ITEM FOR DEVELOPMENT COMMITTEE MEETING

MEETING DATE:	June 16, 2021
NAME & NUMBER OF PROJECT:	3800 Island Way SP-2021-0021D
NAME OF APPLICANT OR ORGANIZATION:	Janis Smith, PE Janis Smith Consulting, LLC
LOCATION:	3800 Island Way Austin, Texas 78746
COUNCIL DISTRICT:	Council District #10
ENVIRONMENTAL REVIEW STAFF	Eric Brown Senior Environmental Scientist Watershed Protection Department Eric.Brown@austintexas.gov
WATERSHED:	Lake Austin Watershed, Water Supply Rural Classification, Drinking Water Protection Zone
REQUEST:	Request to vary from LDC 25-8-281(C)(2)(B) to allow construction within 150-feet of Critical Environmental Feature (Rimrock)
STAFF RECOMMENDATION:	Staff recommends this variance having determined the findings of facts have been met.
RECOMMENDED CONDITIONS:	1. Construction to be completed by barge.

Project Name &
Case Number: **3800 ISLAND WAY Boat Dock Replacement SP- 2021-0021D**

Variance Request: **LDC 25-8-281(C)(2)(b) - To allow construction within 150 feet of a Rimrock Critical Environmental Features (CEF)**

3800 ISLAND WAY
PROPOSED CONDITIONS SITE PLAN

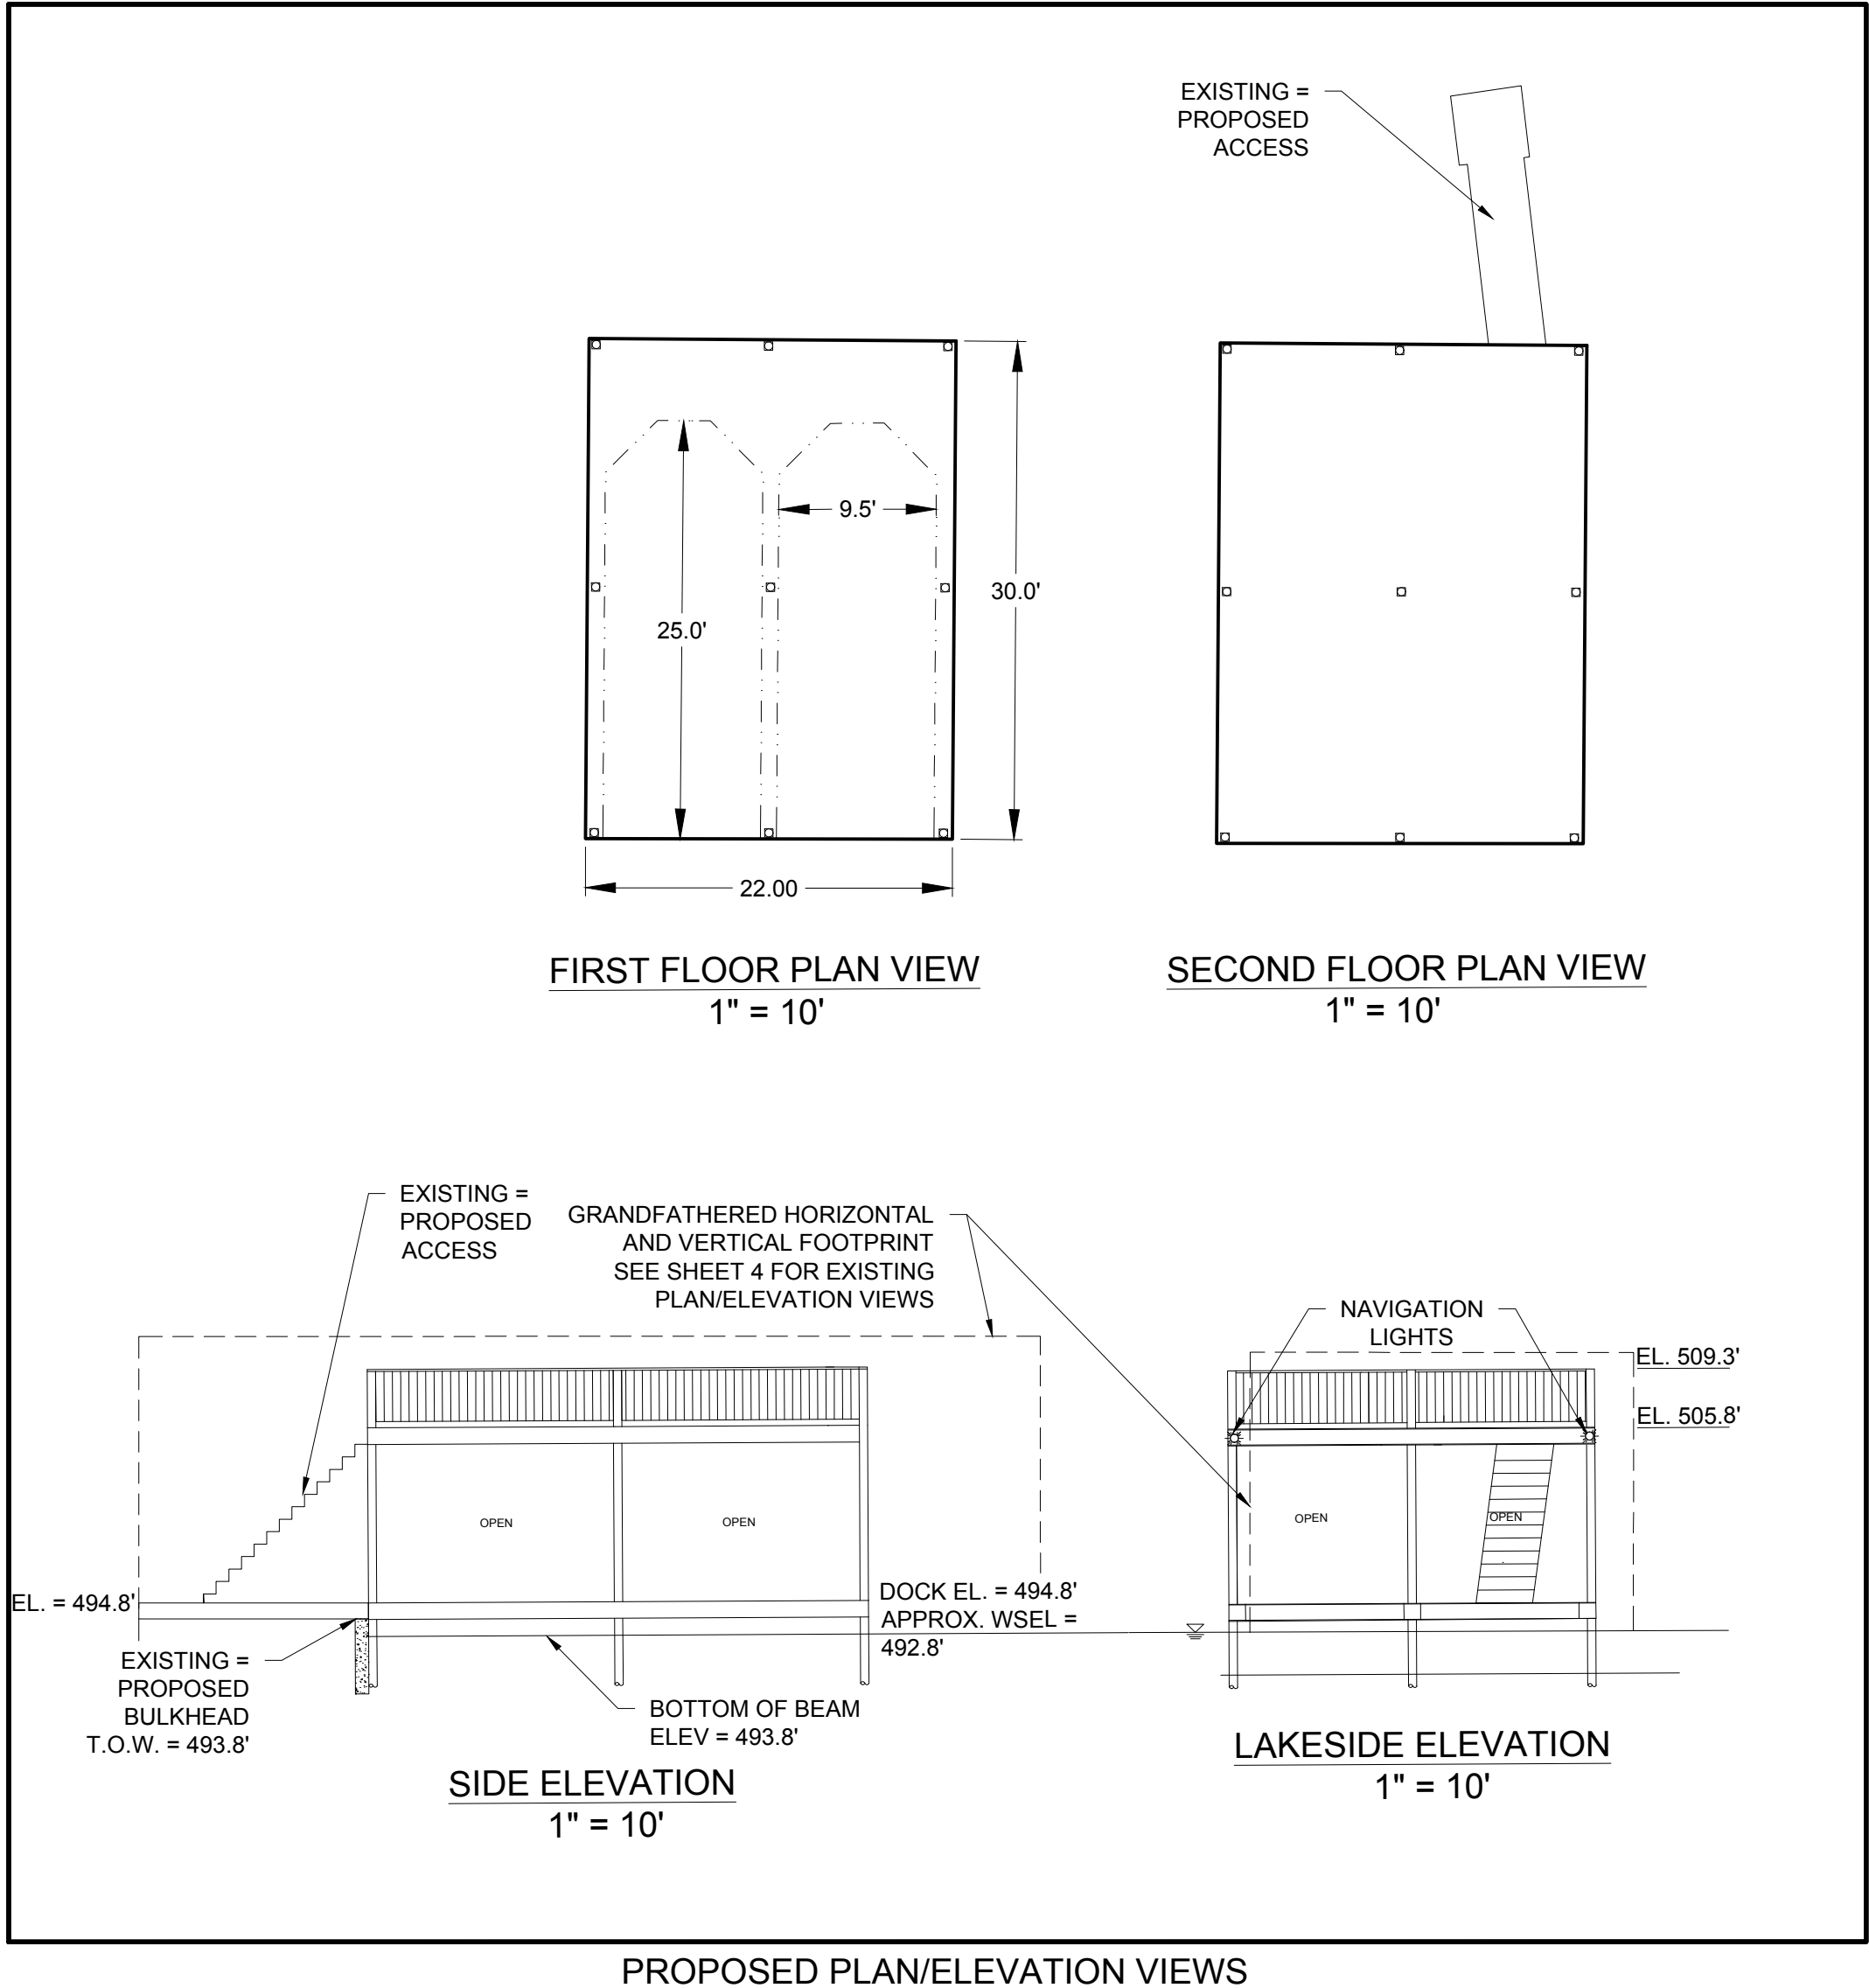
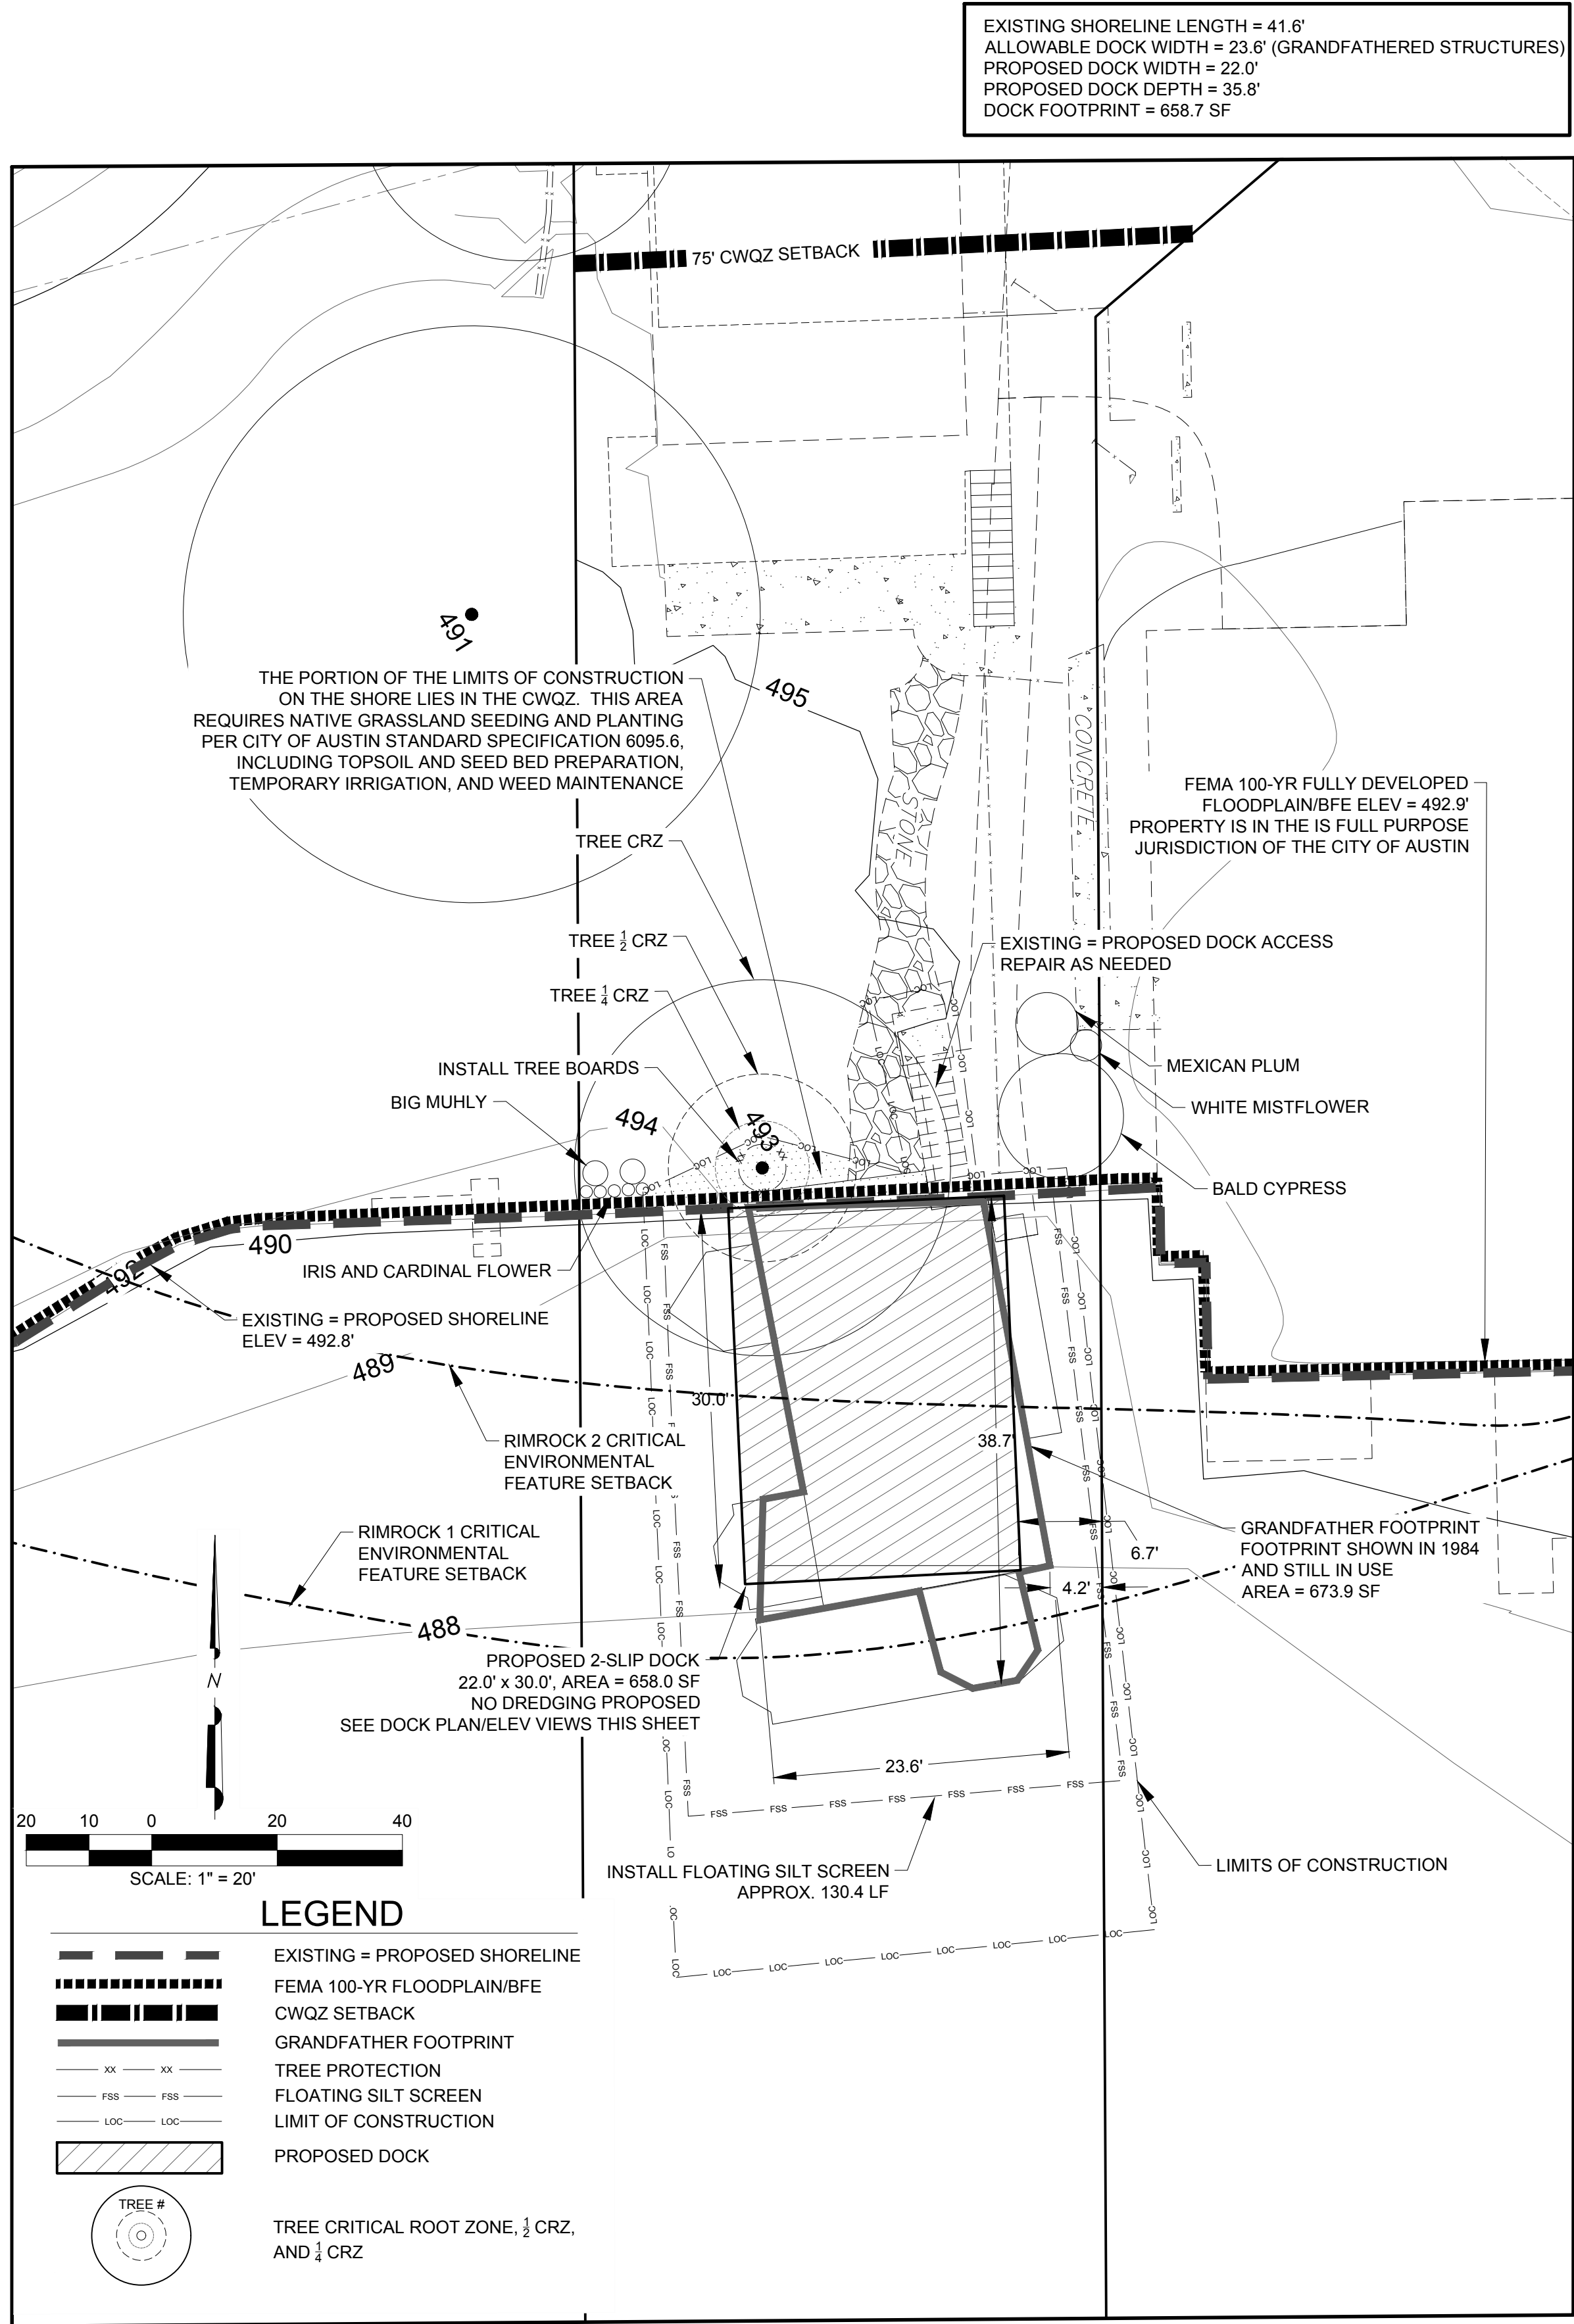
Staff Recommendation: Staff recommends the variance as the Findings of Fact have been met, with the staff recommended condition that all construction be completed by barge.

- ALL WORK SHALL OCCUR WITHIN THE LIMITS OF CONSTRUCTION AS SHOWN ON THE PLAN. ALL MATERIALS WILL BE TRANSPORTED TO THE SITE FROM WATER. ALL CONSTRUCTION ACTIVITY, INCLUDING STAGING AND SPOIL STORAGE, WILL BE COMPLETED BY WATER.
